NUCLEAR REGULATORY COMMISSION

Title:	Advi	sory Committee on Reactor Safeguards Northwest Medical Isotopes Subcommittee Open Session
Docket Numbe	er:	(n/a)
Location:		Rockville, Maryland
Date:		Tuesday, July 11, 2017

NORTHWEST MEDICAL ISOTOPES (NWMI) SUBCOMMITTEE

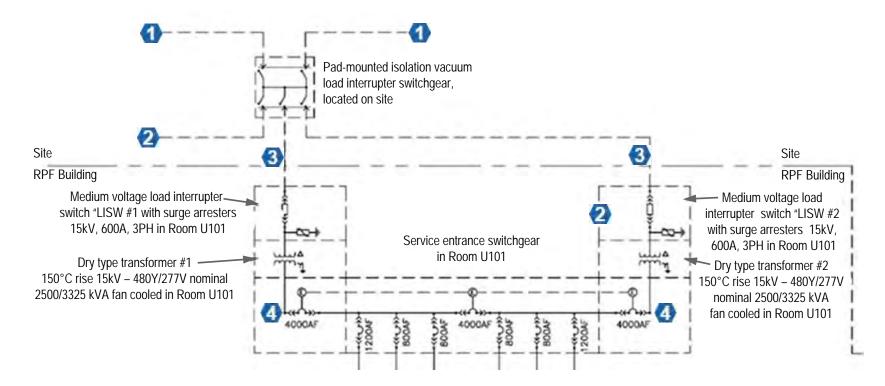
145
1	an electric plant, this was brought up earlier that
2	the Figure 8-1 or whatever it was, whichever the
3	appropriate figure is, did not show any UPSs. And then,
4	we talked a little bit about UPSs.
5	Part of the discussion here, is, and
6	there's a number of them.
7	MR. DUNFORD: Yes.
8	MEMBER BROWN: Did the UPSs, each
9	individual UPS, have its own battery or is there a larger
10	station battery that supplies all UPSs or has that been
11	thought through as to how you're going to do that?
12	MR. DUNFORD: I believe from looking
13	at the floor plan and the discussions I have heard,
14	I think that both of those things are happening.
15	There are a a larger battery location,
16	but there are also individual UPS power around the
17	facility.
18	MEMBER BROWN: Okay, let me I didn't
19	see it. So, each if a process has a UPS associated
20	with it, because you all identified several processes
21	that would have their own that would have UPSs, some

157
1	at this stage.
2	If you look at if you all have access
3	to Figure 8-1, a couple of other points that were brought
4	up earlier and I wanted to mention here, according to
5	the note, Note 5, or excuse me, Note 4 on Figure 8-1,
6	both of the input power transformers to the facility
7	are full capacity transformers, as are all of the
8	associated wiring and switchgear.
9	The breaker, the tiebreaker is normally
10	open and the note says that, in the event that there's
11	a need for this, that the tiebreaker can be closed after
12	and the full power can be supplied from side or the
13	other.
14	It doesn't indicate whether that's
15	automatic, it just says can be closed and it'll carry
16	the full building load.
17	The other thing I noticed here is that,
18	on standby switchboard, switchboard number two, there
19	are some breakers shown on there that don't have any
20	loads.
21	And, again, we don't know this level of

20	releases of radioactivity to the environment.
21	If you'll notice again on system on,
22	excuse me, on Figure 8-1, we may be used to seeing loads
23	that are powered normally and then are powered
24	alternatively from a diesel bus.
25	In this case, we've got all of the loads
	NEAL R. GROSS
